# Access Compliance Report

## Public Rights-of-Way

Intersection ID: 10038458	Main Street: SOUTHERN_PINE_BV	Cross Street: N/A	Location: S
ADA ID: 2438160C8C52	Ramp Type: PerpDiag	Initial Pass/Fail: Fail	Overall Compliance: No
Severity Score: 37.5			
Codes/Mitigation Info/Possible Solution		Field Measurements/Component Compliance

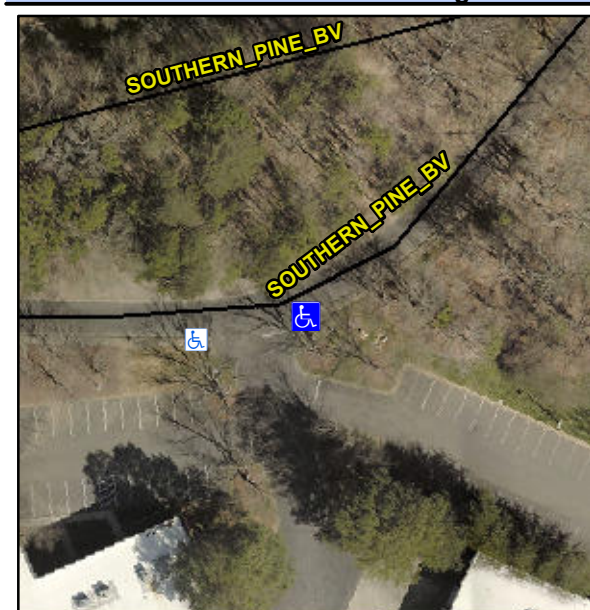
**Remove & Replace Curb Ramp With Two New Directional Ramps or Equivalent.**

**Not Found, R304.2.2, R304.5.3**
